RULE NO.: R161-16.01

NOTICE OF PROPOSED RULE

R161-16.01: Proposed revision to the Standards Manual Section

<p>CITY OF AUSTIN WATER AND WASTEWATER UTILITY</p>	<p>VALVE BOX CASTING C-6 PAVING RING</p>
<p>RECORD COPY SIGNED BY KATHI F. PAYNE</p> <p>4/5/99</p> <p>ADOPTED</p>	<p>THE ARCHITECT/ENGINEER ASSUMES RESPONSIBILITY FOR APPROPRIATE USE OF THIS STANDARD.</p> <p>STANDARD NO. 511S-14</p>

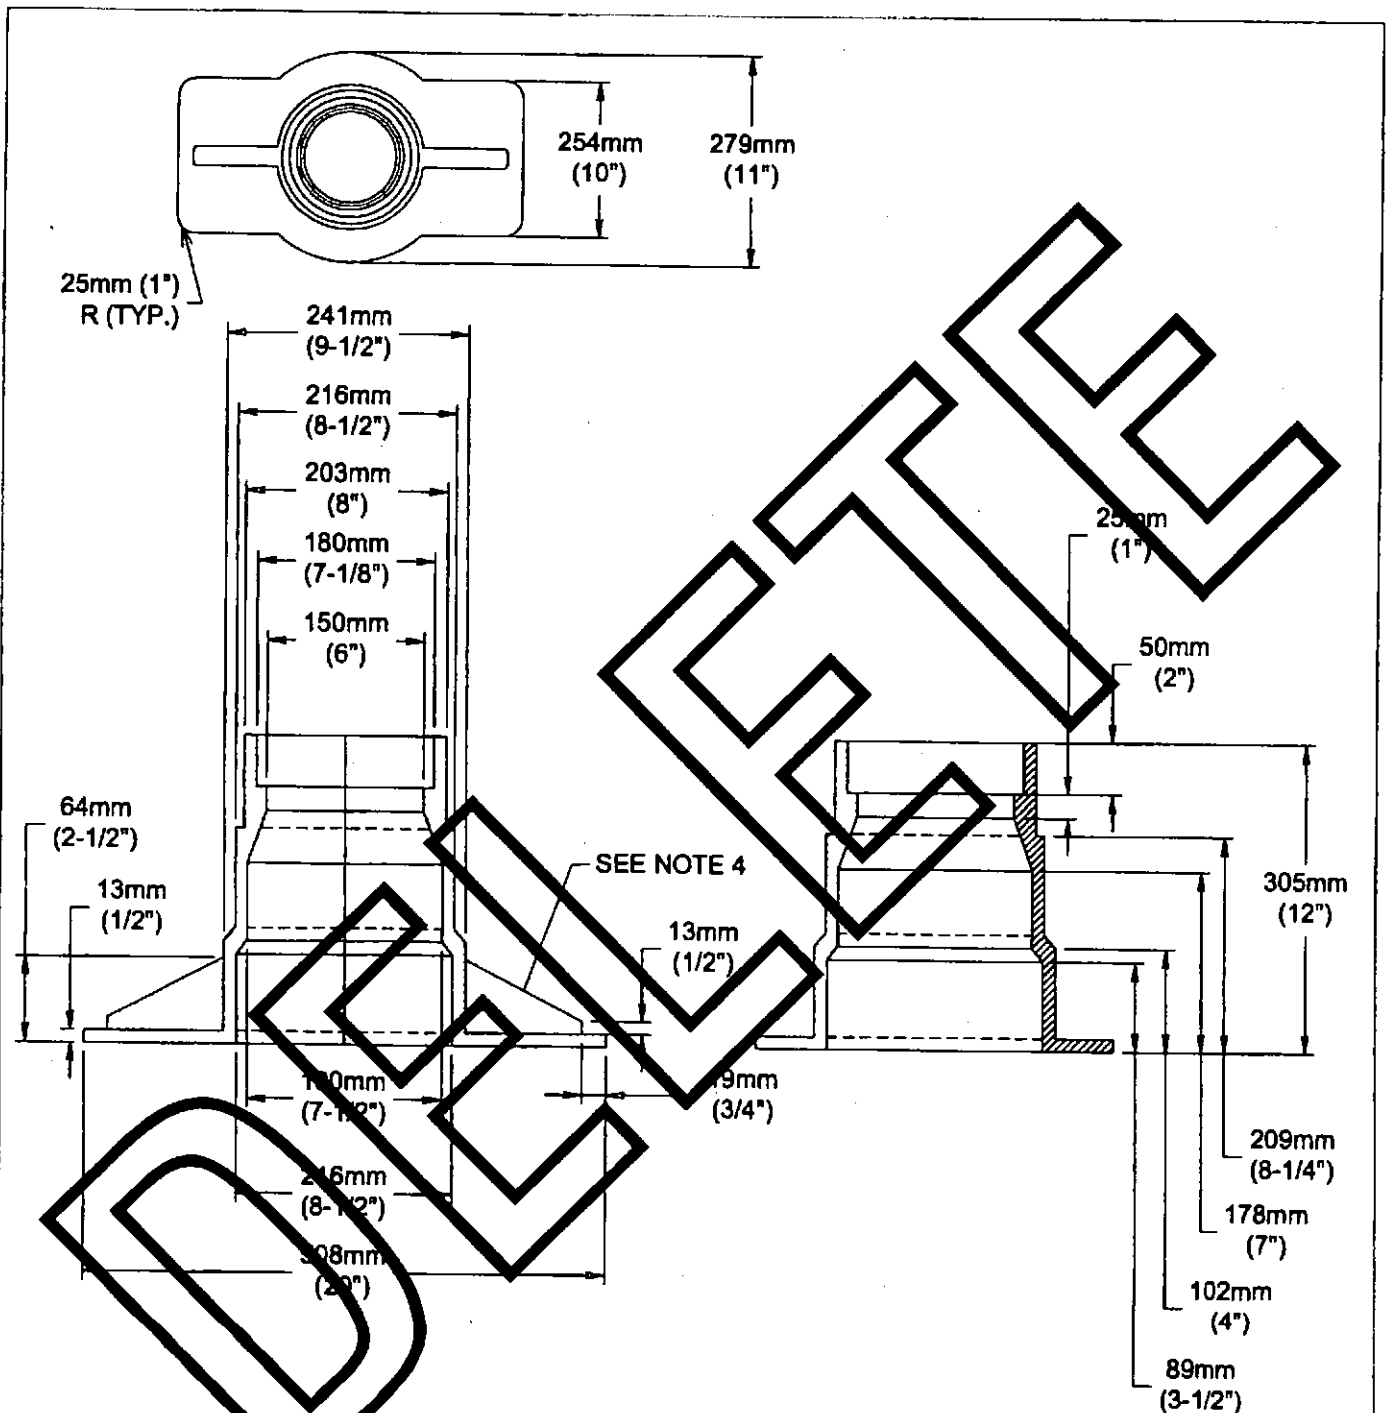
- **511S-13C** Water Valve Box Concrete Pad in Unpaved Area – Delete
- **511S-14** Valve Box Casting C-6 Paving Ring - Delete
- **511S-15** Valve Box Casting Base – Delete

- **511-20** Automatic Flush Valve - Delete
- **511-AW-01** Typical Gate Valve 4" – 16" – New Detail and New Number
 - Combine 511S-7, 511-11, 511S-11R, 511S-12, 511-13A, B & C, 511S-14, 511S-15 and 511S-16 into one Standard

CITY OF AUSTIN WATER AND WASTEWATER UTILITY		VALVE BOX CASTING C-5A COLLAR	
RECORD COPY SIGNED BY KATHI F. PAYNE	4/5/99	THE ARCHITECT/ENGINEER ASSUMES RESPONSIBILITY FOR APPROPRIATE USE OF THIS STANDARD.	STANDARD NO. 511S-16
ADOPTED

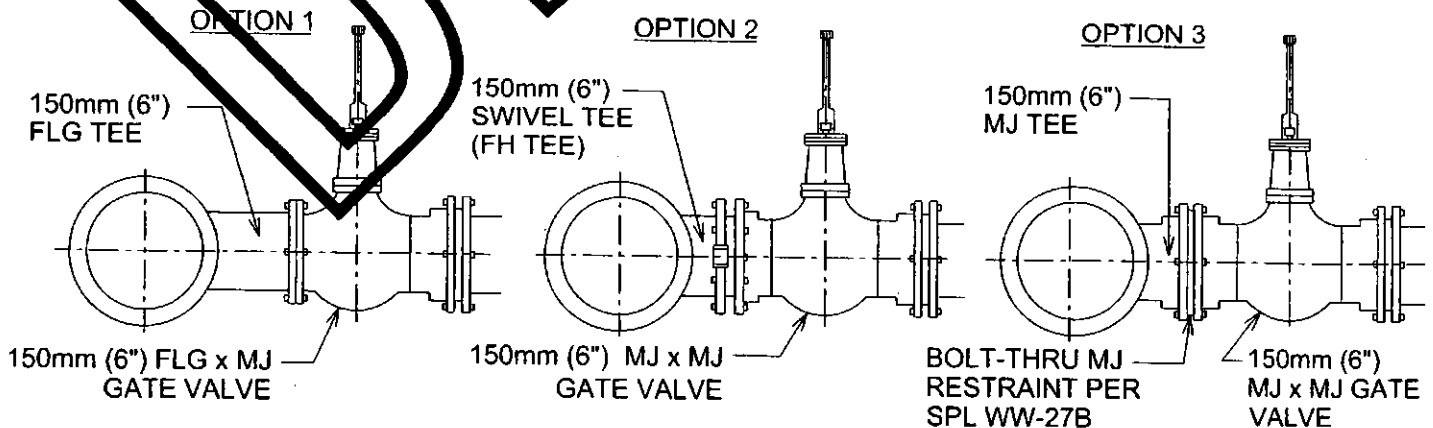
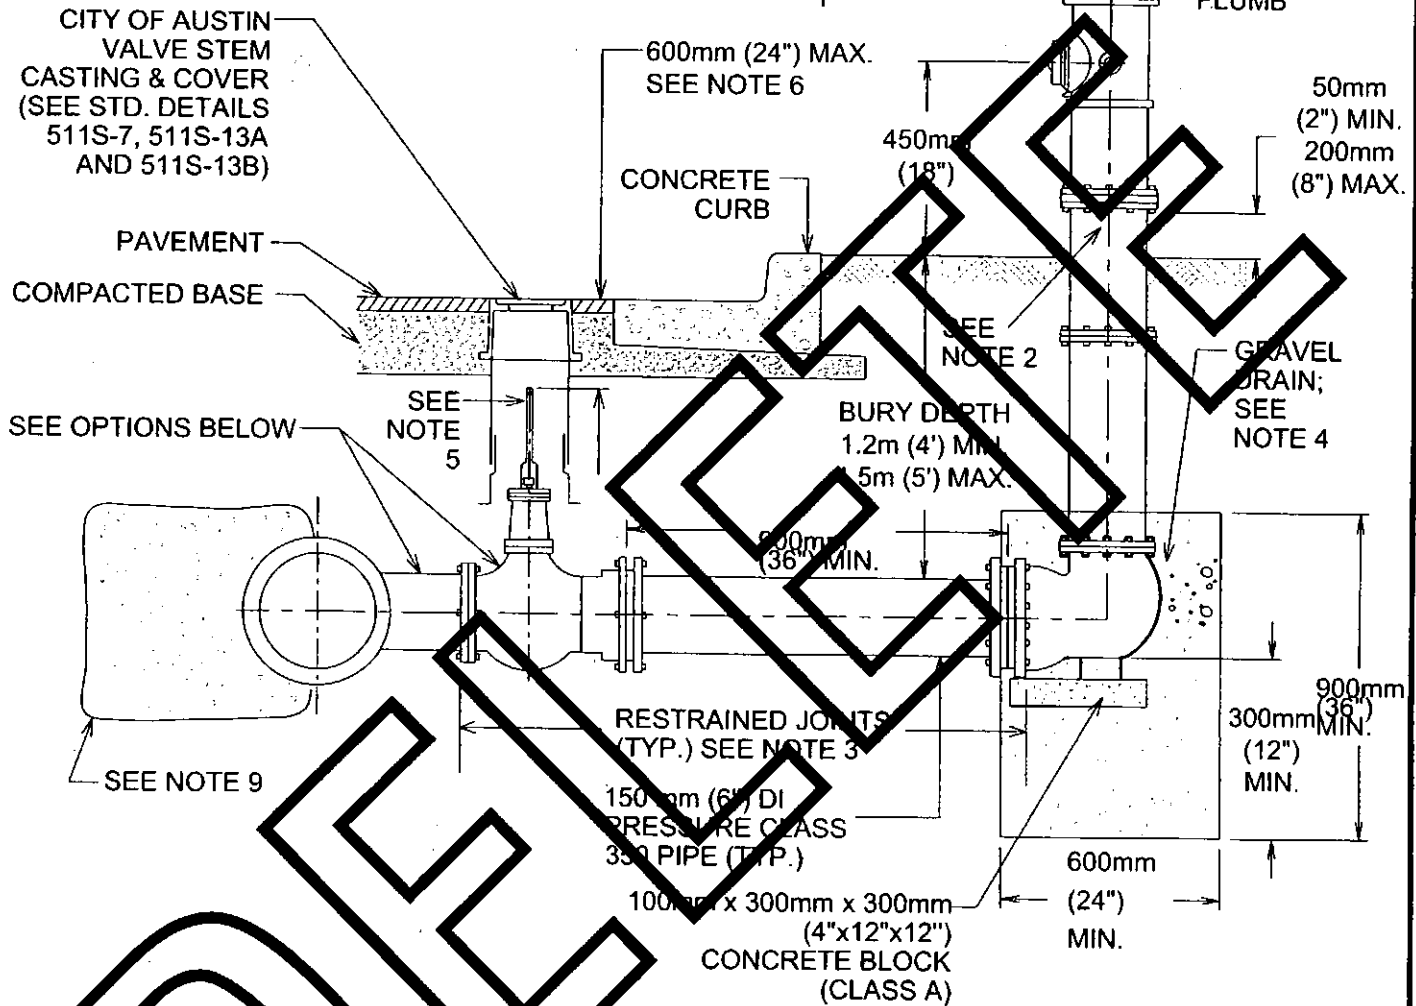
- **511S-16** Valve Box Casting C-5A Collar – Delete
- **511S-17** Standard Fire Hydrant Installation - Delete
- **511S-17A** Fire Hydrant Installation on Deep Water Mains - Delete

DEEP MAIN FIRE HYDRANT
INSTALLATION w/90° BEND

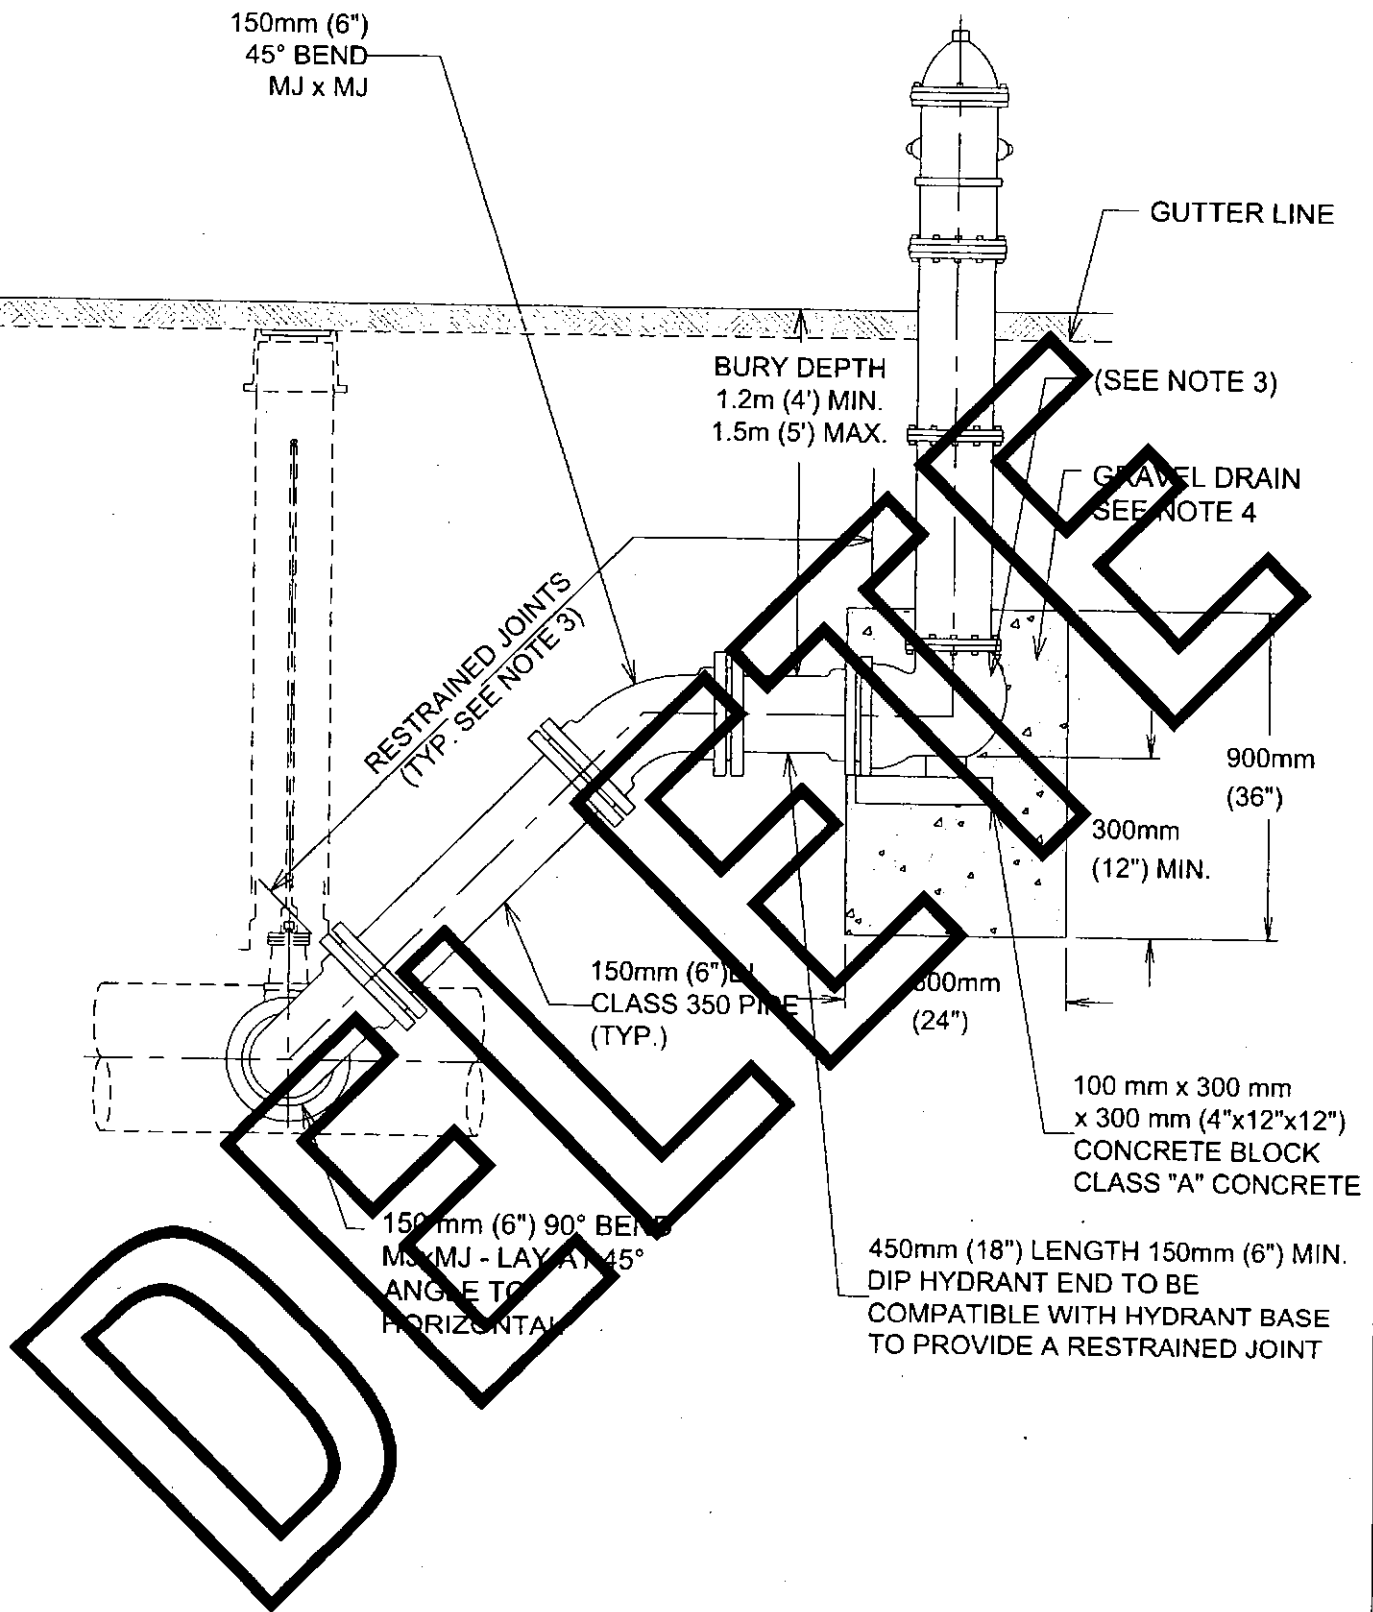
- **511S-17B** Deep Main Fire Hydrant Installation w/90° Bend- Delete
- **511S-18** Fire Hydrant Installation With PRV - Delete
- **511S-19R** Reclaimed Water Connection 4" Non-Traffic Rated, Non-Freezing Blow-Off Valve – Delete

- **511-AW-02** Fire Hydrant – New Detail and New Number
 - Combine 511S-17, 511S-17A & B, 511S-18 into one Standard
- **511-AW-03** Drain Valve – New Detail and New Number
